APPEAL SUMMARY

Status: Decision Rendered - Reconsideration of ID 25069

Appeal ID: 26206	Project Address: 531 SE 14th Ave
Hearing Date: 10/6/21	Appellant Name: Tom Jaleski
Case No.: B-016	Appellant Phone: 5038607501
Appeal Type: Building	Plans Examiner/Inspector: Jeff Rago
Project Type: commercial	Stories: 5 Occupancy: A-2, A-3, B, M, S-1 Construction Type: II-A
Building/Business Name: Revolution Hall	Fire Sprinklers: Yes - Throughout
Appeal Involves: Reconsideration of appeal	LUR or Permit Application No.:
Plan Submitted Option: pdf [File 1] [File 2]	Proposed use: Office, retail, assembly

APPEAL INFORMATION SHEET

1 PLAN - LEVEL 2 AUDITORIUM REMOVABLE HANDRAIL
1/4" = 1'-0"

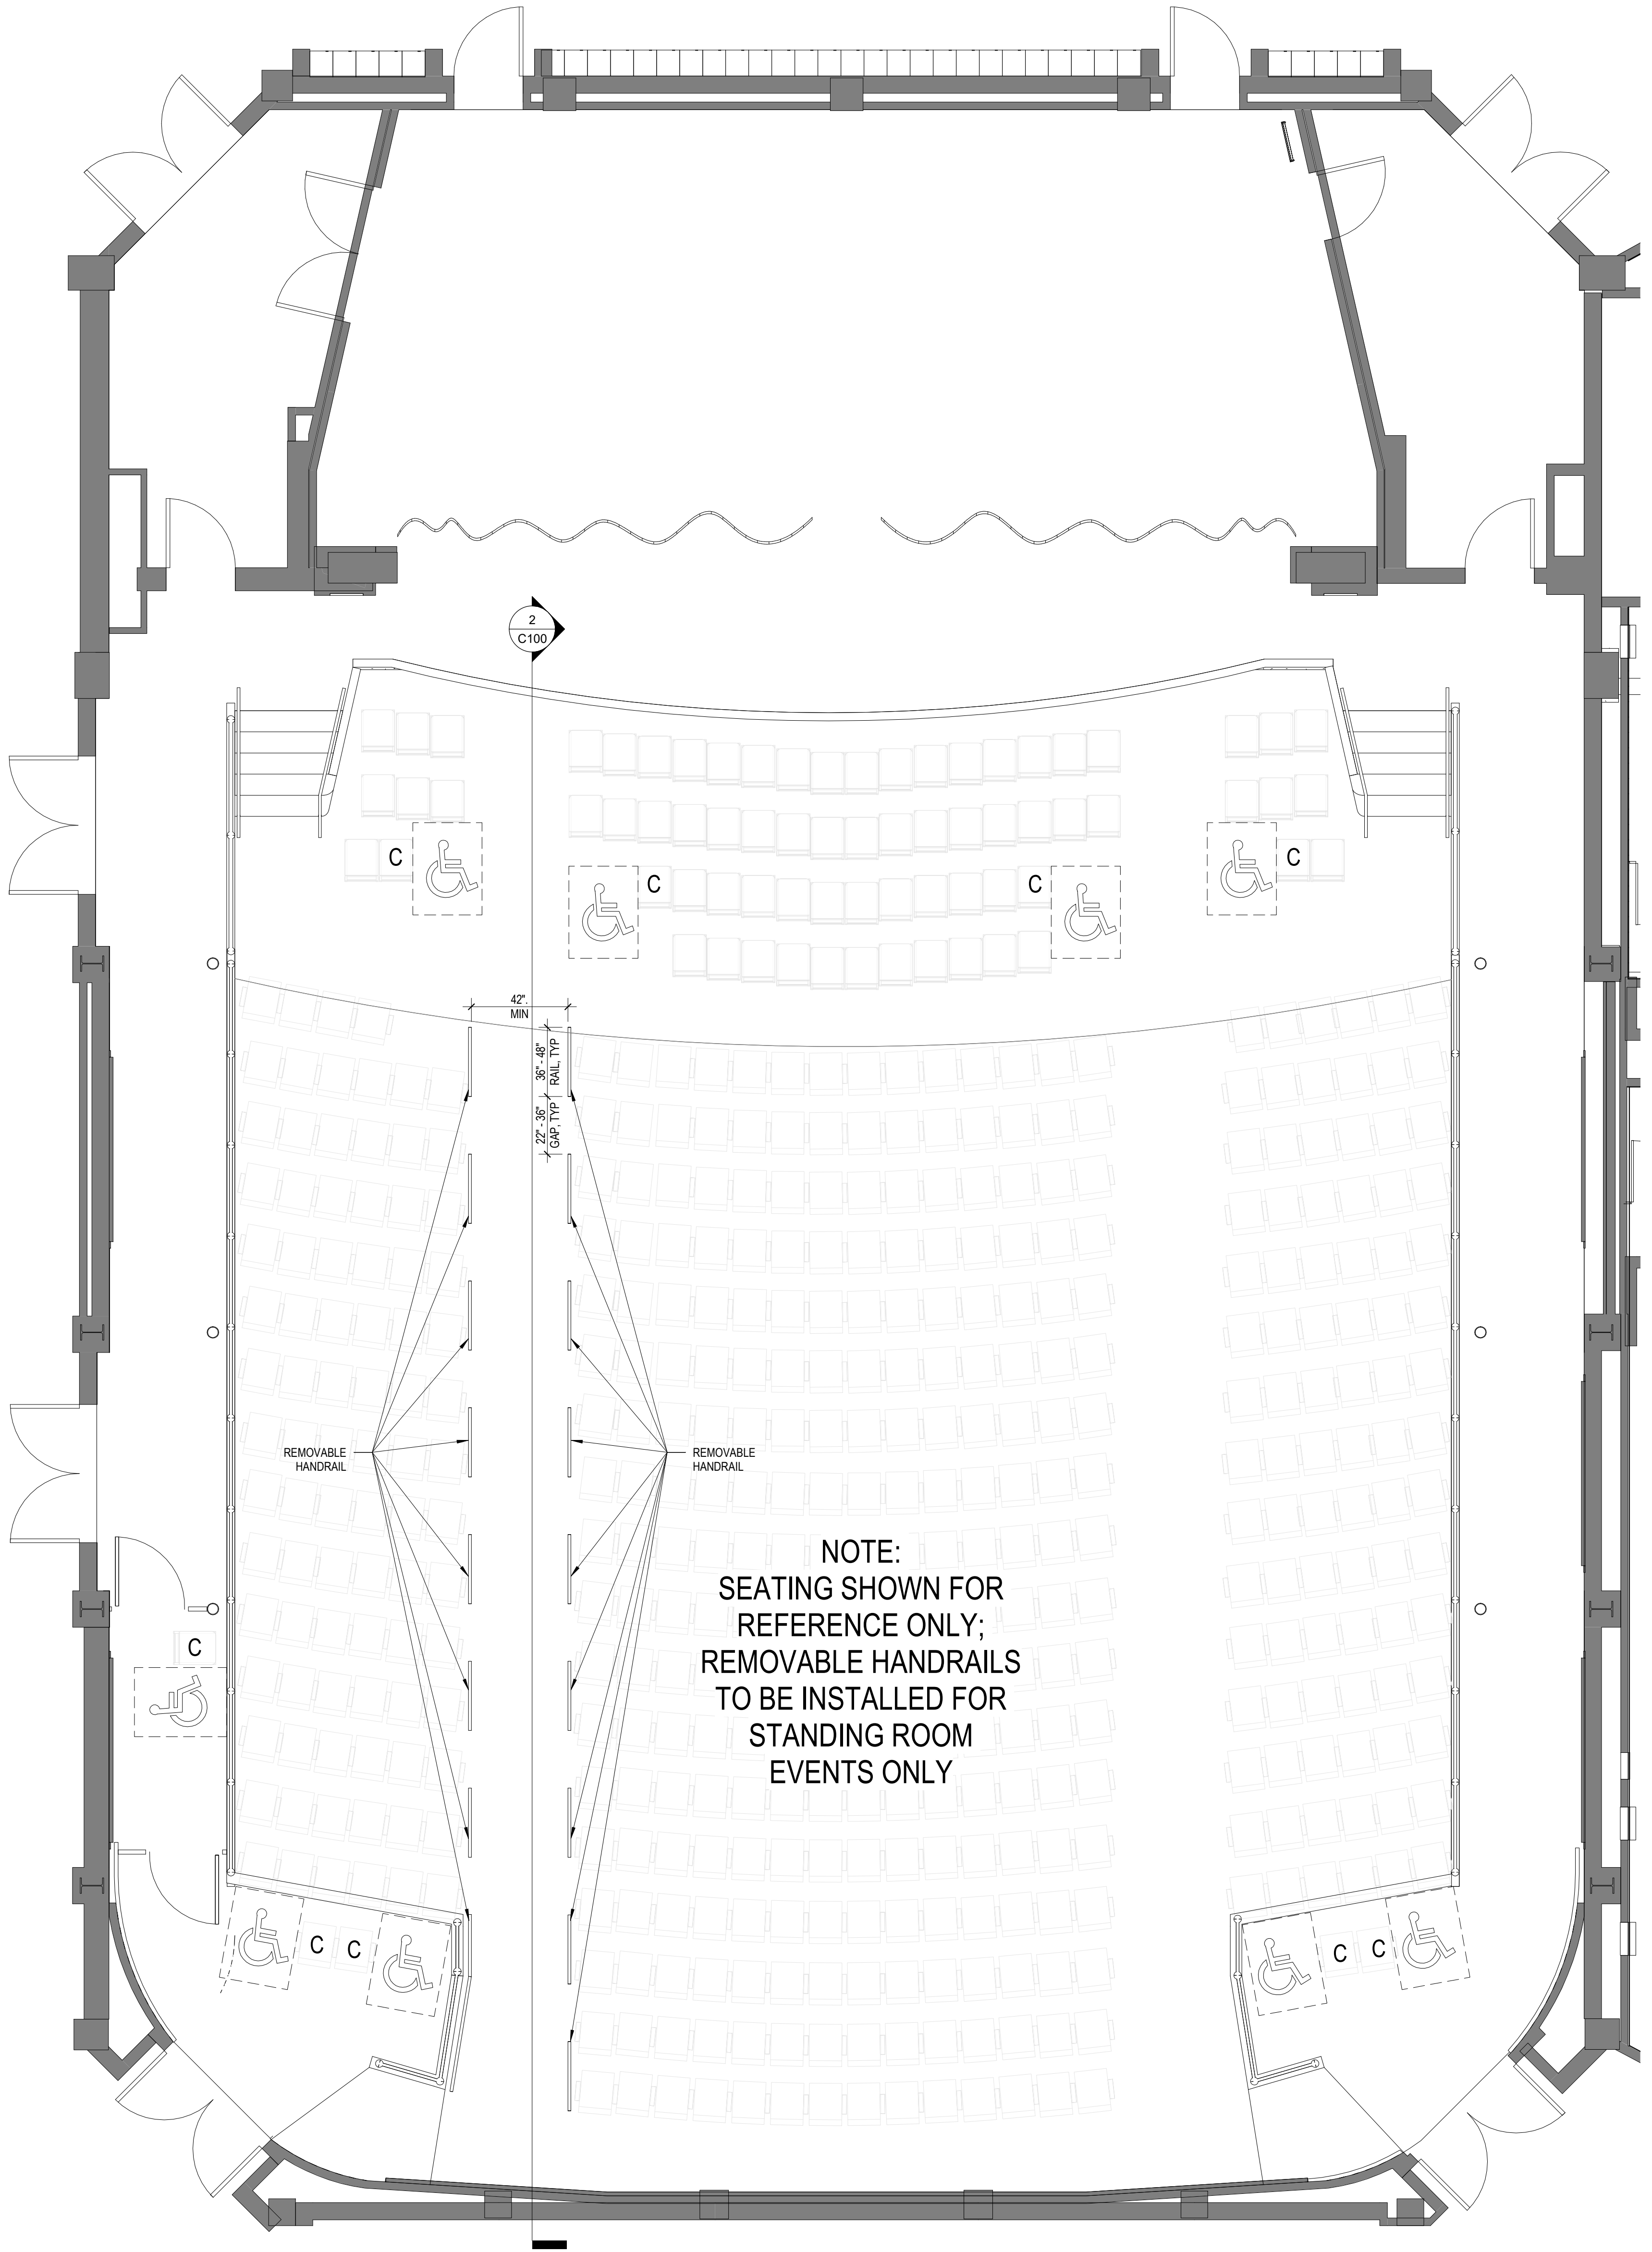
Code Section	1012.8
Requires	Ramps with a rise greater than 6 inches shall have handrails on both sides. Handrails shall comply with Section 1014.
Code Modification or Alternate Requested	<p>To allow the 1:16 sloped floor portion of the auditorium to be used as standing room occupiable area with handrails compliant with sloped aisles requirements.</p> <p>RECONSIDERATION TEXT</p> <p>No Change (except added ICC opinion and change to Reason portion based on ICC opinion)</p>
Proposed Design	<p>The former Washington High School is now being used as an event space, and office space. The former school auditorium is now used to host music and other assembly events. The auditorium is on the second floor of the building with a balcony. The auditorium and building was permitted to meet 2010 OSSC requirements as part of the renovation to current use.</p> <p>The auditorium is currently permitted with fixed seating, providing an occupant load on the main floor level of 442 occupants with an additional 84 occupants in movable seats that can be removed for certain events. Total permitted occupant load is 529 on the main floor, building level 2. On building level 3, 301 additional fixed seats are located for a total occupant load in the auditorium of 830 occupants.</p> <p>The proposed design is to replace all existing fixed seating (except the designated ADA seating and its accompanying seat) with removable seating. When all seats on the lower level of the auditorium are removed, the standing room tickets will be sold to maintain fixed seating occupant load that is currently permitted. The proposed design for removable handrails provides stability</p>

The proposed design is to allow the 1 vertical unit in 16 horizontal units ramped floor for standing for events with handrails being added that meet the requirements of OSSC 1029.9, 1029.14, and 1029.16, see attached plan for location. Ramped aisles are acceptable to the code as long as there is something to stabilize walking. OSSC 1029.16, exception shows that the code allows seat backs or handrails to provide this stability. These items also work to provide the necessary stability for disabled people in this special condition that does not need to conform to OSSC 1012.8 for handrails on a standard ramp.

The attached plan and section show where the handrails will be located when seating is removed. This location is the same route that wheelchair occupants would use to access the permitted accessible seating location near the stage. The handrails simply replace the seatbacks for use. The handrails are fully compliant with sections of OSSC Section 1029 for handrails at a sloped aisle, including breaks to allow for occupants to access the areas beyond the handrails.

Use of 1:16 sloped floor to be used as standing room occupiable area with handrails compliant with sloped aisles requirements: Denied. Proposal does not provide equivalent Life Safety protection. Appellant may contact John Butler (503 865-6427) or e-mail at John.Butler@portlandoregon.gov with questions.
